Commonwealth Edison Company

August 31, 1971

Subject: Proposed Change No. 14 to Appendix A,
DPR-19, AEC Dkt 50-237

TRANSIENT ANALYSES OF PROPOSED TESTS FOR WHICH A TEMPORARY WAIVER OF FLOW
REFERENCED SCRAM IS REQUESTED AND A FIXED 120% APRM FLUX SCRAM IS PROVIDED

Figure 2.1.1. APRM Flow Reference Scram and APRM Rod Block Settings

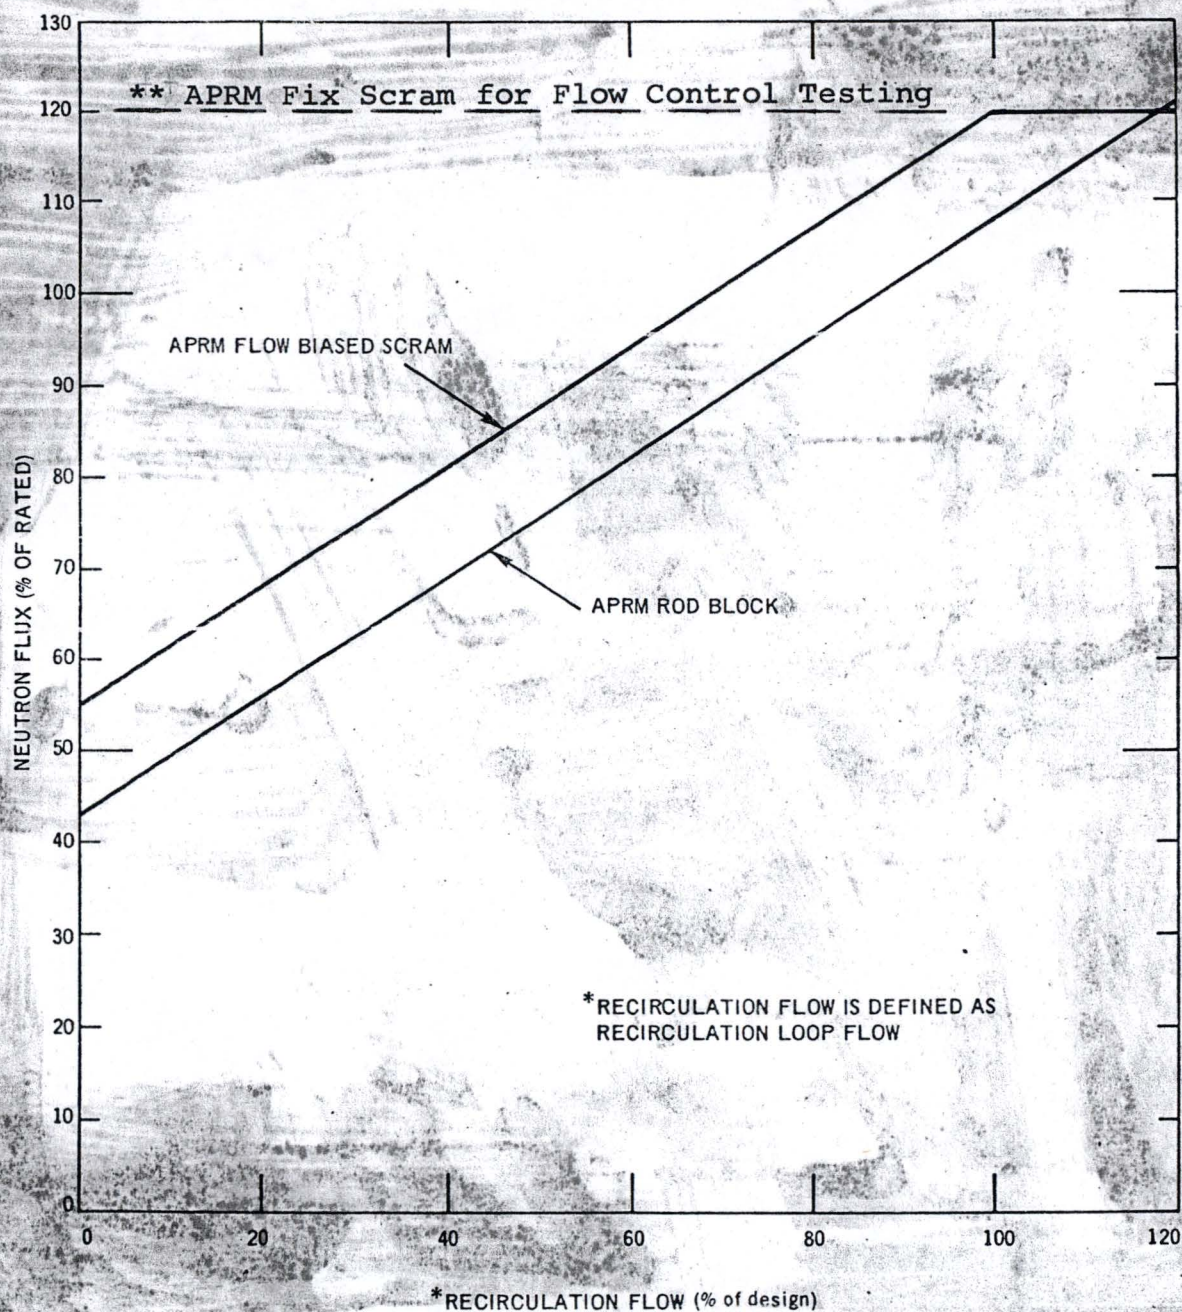
Pursuant to Section 50.59 of 10 CFR Part 50 and paragraph 3.B of the Facility License DPR-19, Commonwealth Edison Company hereby submits Proposed Change No. 14 to Appendix A of DPR-19 (Dresden Unit 2). The purpose of this change is to request a fixed 120 percent High Flux APRM Scram during start-up testing to determine the warranted load response capability of Dresden Unit 2. This test is discussed in Start-up Test Procedure No. 17. This change will be in effect only during the time when the tests are being run. The specific change to the technical specifications is included in the attached page.

** The 120% fixed scram will be utilized only during the warranted load response test (see start-up test 17). Following completion of this test the flow bias scram will be utilized.

Fig 1A-1

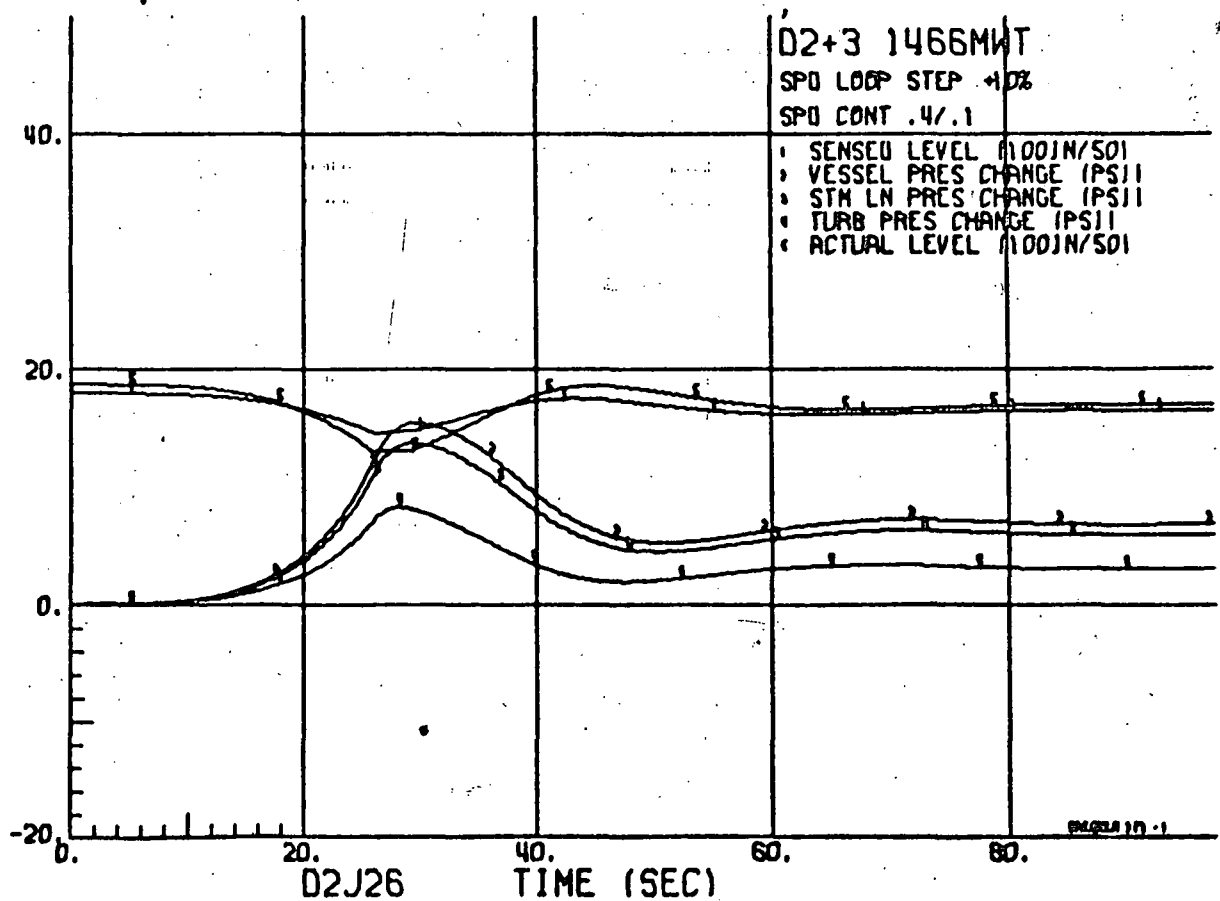
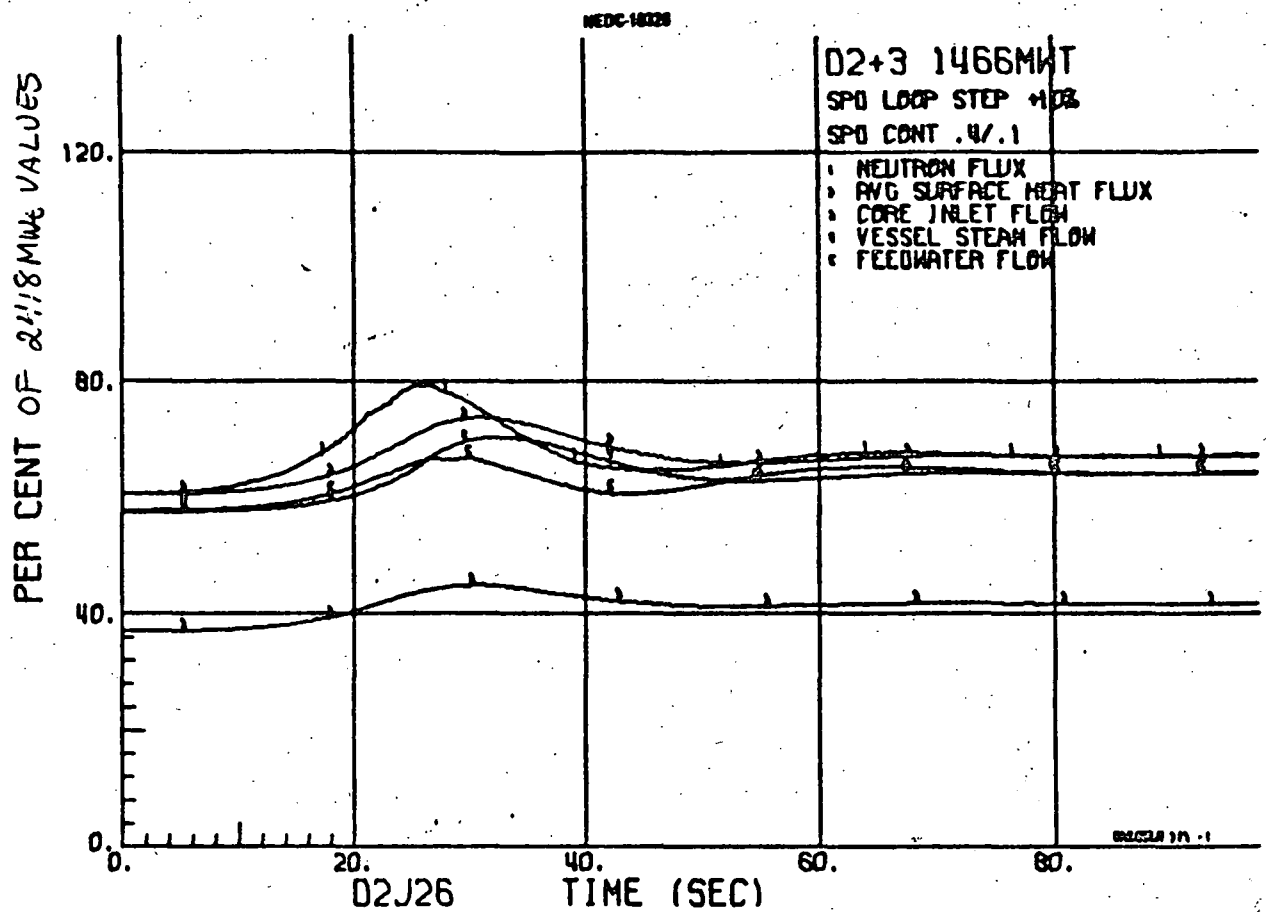
Figures 1A-1 and 1A-2, (attached), show the expected plant response to such a speed demand increase when initiated from the low 20% speed end of the 100% load line. Initial reactor power is approx 58% of 2527 MWt (61% of 2418 MWt). Figures 1B-1 and 1B-2 show the expected plant response to a 10% speed increase demand from the initial condition of 70% of 2527 MWt on the 100% load line. On the bottom plots of both Figures 1A-2 and 1B-2, note the proximity of neutron flux to the flow referenced scram line and the lag of actual power (indicated by the average surface heat flux trace) which essentially proceeds upward along the 100% load line.

Fig 2A-1

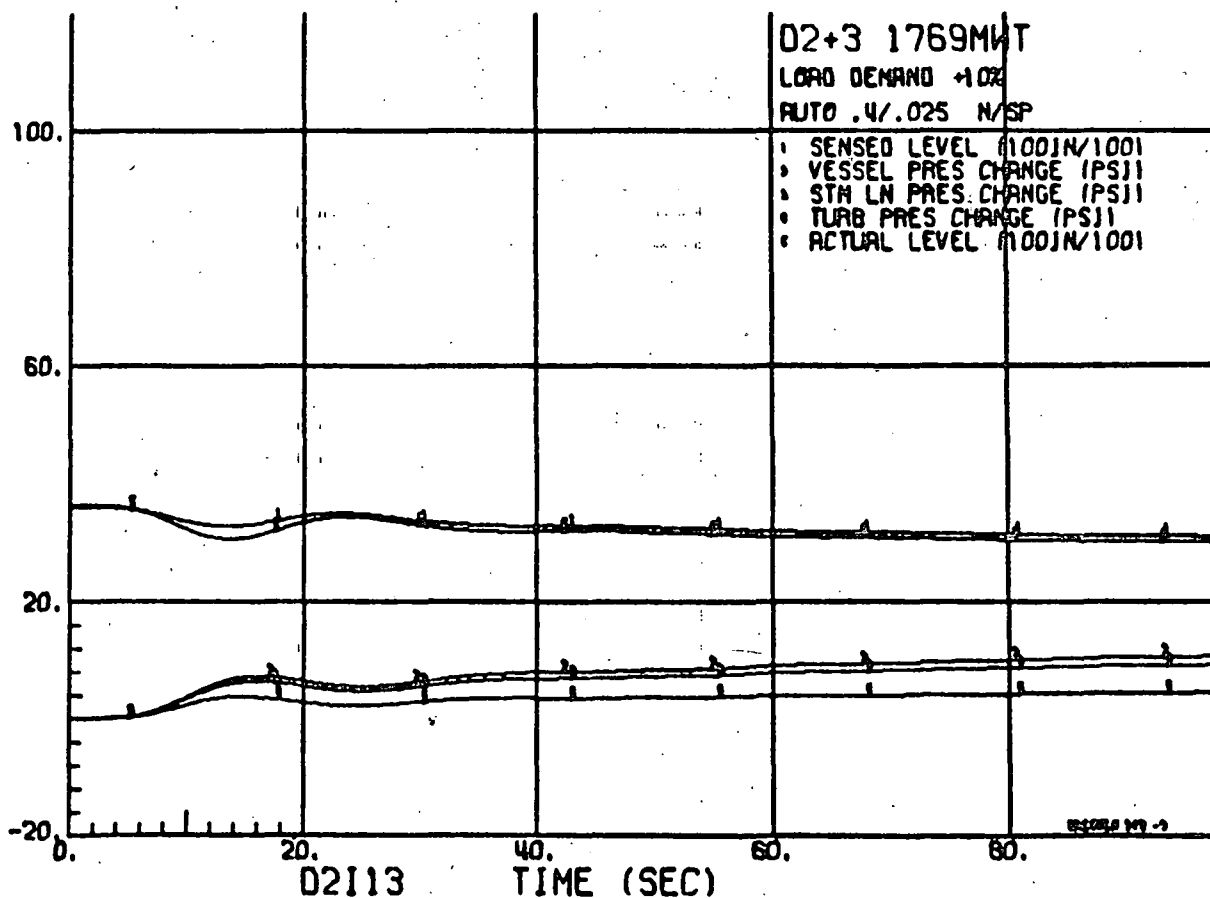
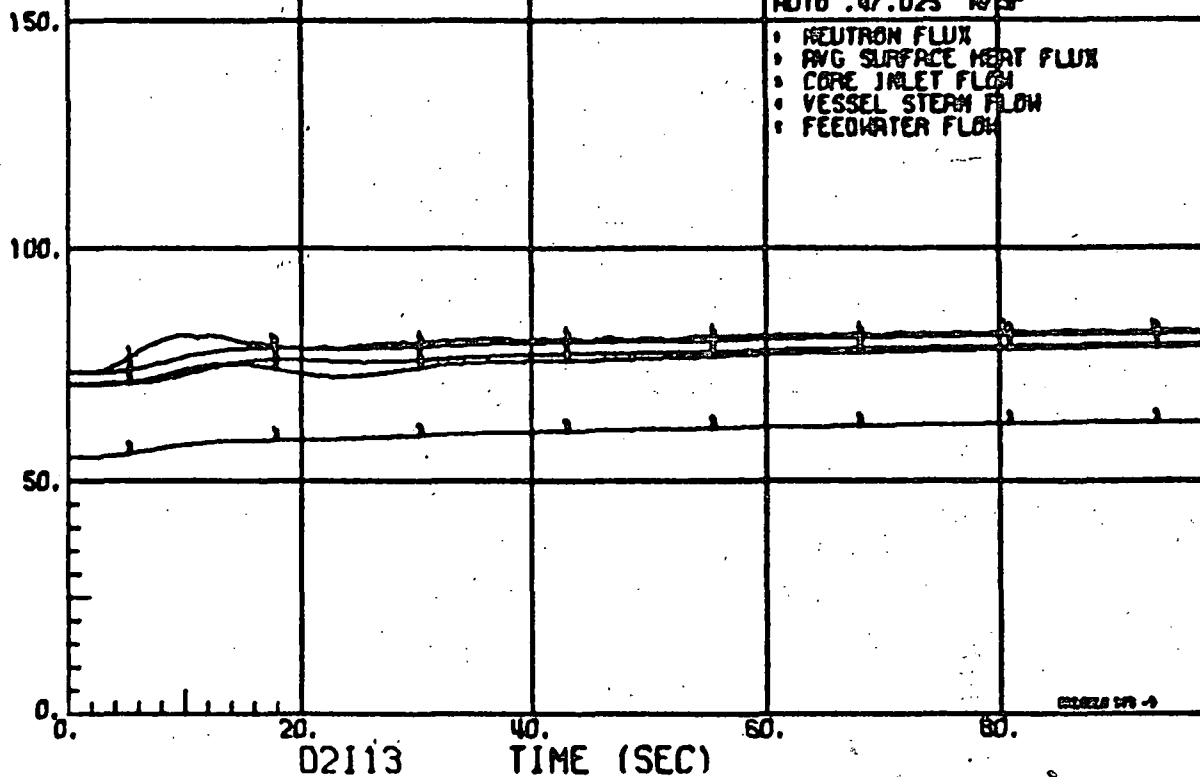
Figures 2A-1 and 2A-2 show the expected plant response to a 10% step load demand increase with no transient setpoint adjuster action and with master flow controller proportional gain setting at 1/2 of the expected optimum value and reset gain at 1/4 of the expected optimum setting.

Fig 2B-1

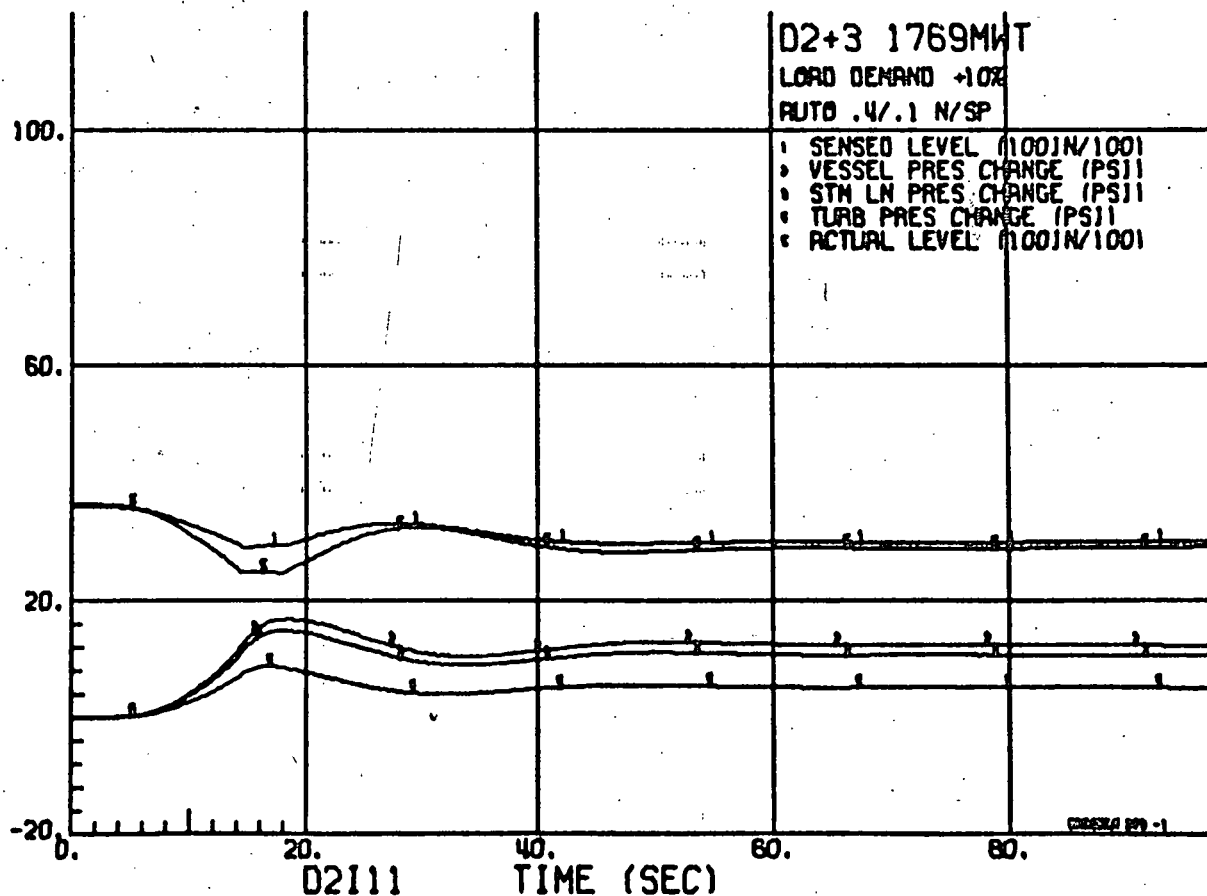
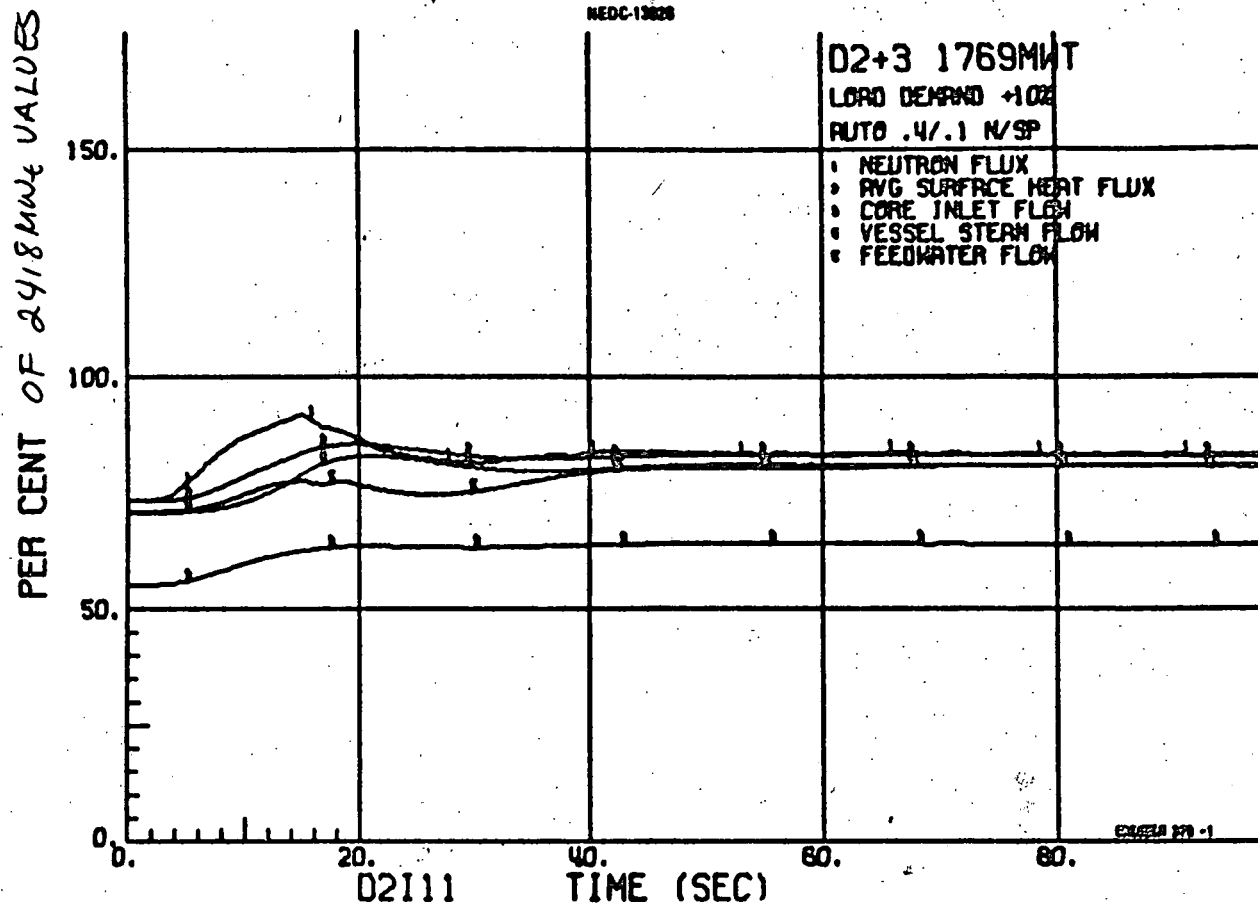
Figures 2B-1 and 2B-2 show the expected response to a 10% load demand step without transient setpoint adjuster and with Master Flow Controller proportional gain setting increased to 1/2 of the expected optimum value and reset gain increased to the expected optimum value.

Fig 2 C-1

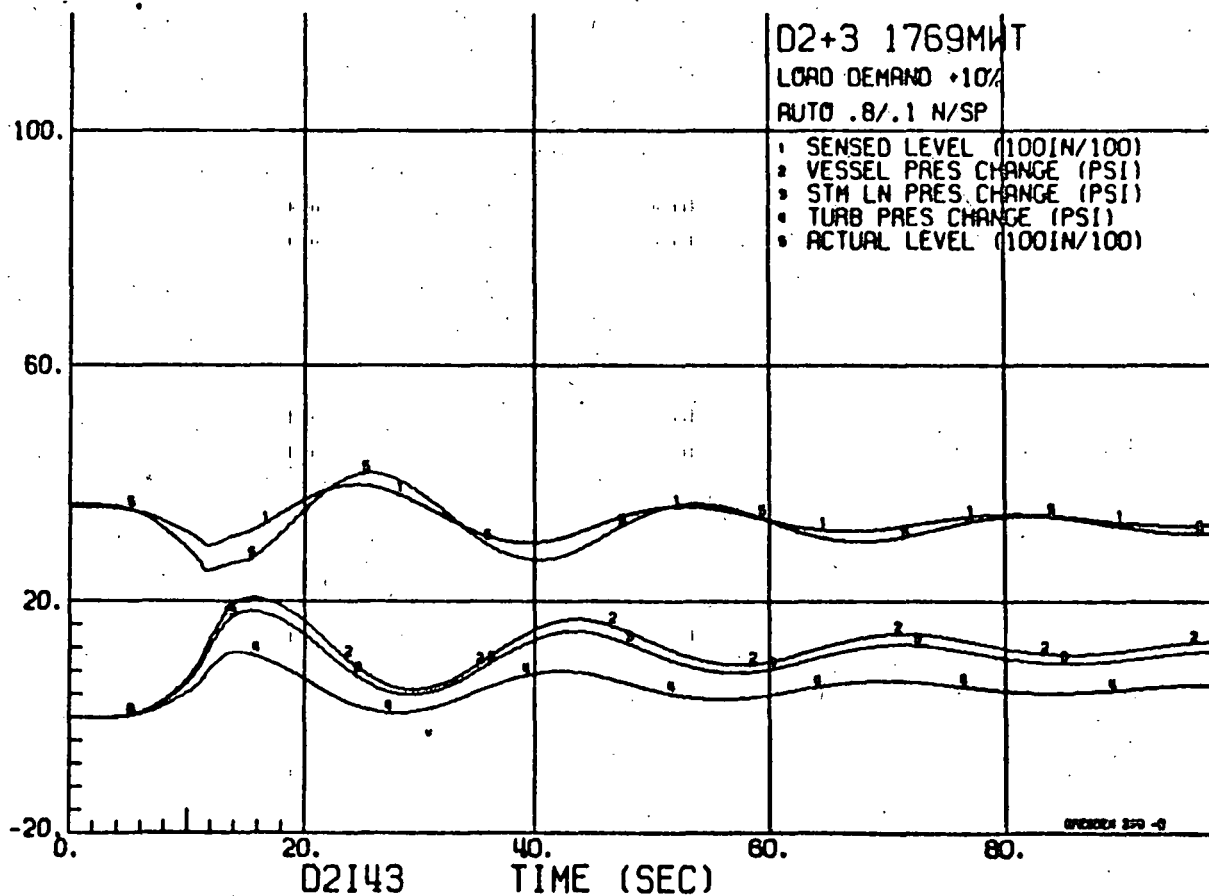
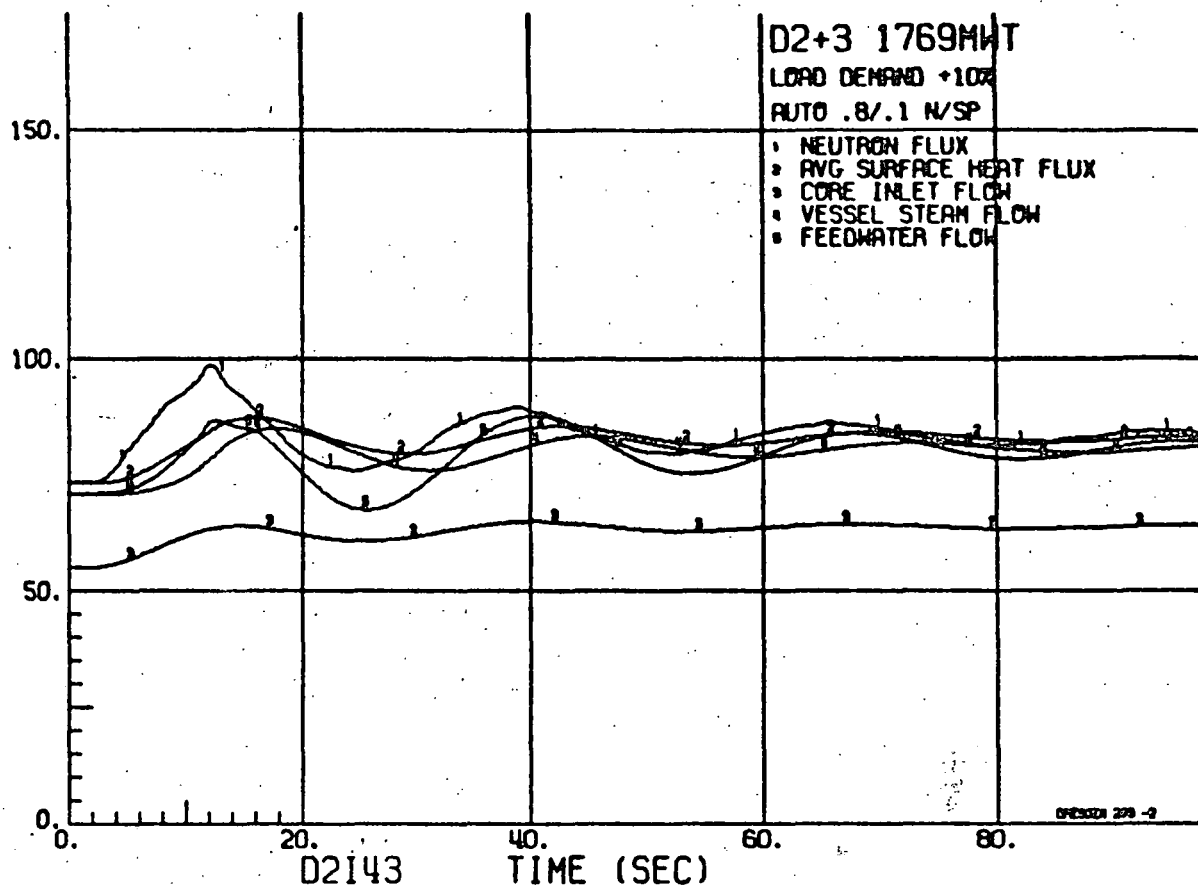
Figures 2C-1 and 2C-2 show the expected response without transient setpoint adjuster with both proportional gain and reset gain of the Master Flow Controller at the expected optimum values. Note that interference by flow referenced scram is predicted by this analysis. This analysis is also significant as it shows the response of the plant for the case of a failure of the transient setpoint adjuster in an "as is" failure mode. Plant response is sufficiently damped such that if such a failure should occur while the plant is operating in the automatic flow control mode, the operator can easily transfer to the manual mode of operation. The final settings of the Master Flow Controller will be such that the decay ratio of the response will 1/2 or lower without a transient setpoint adjuster as shown in the analysis.
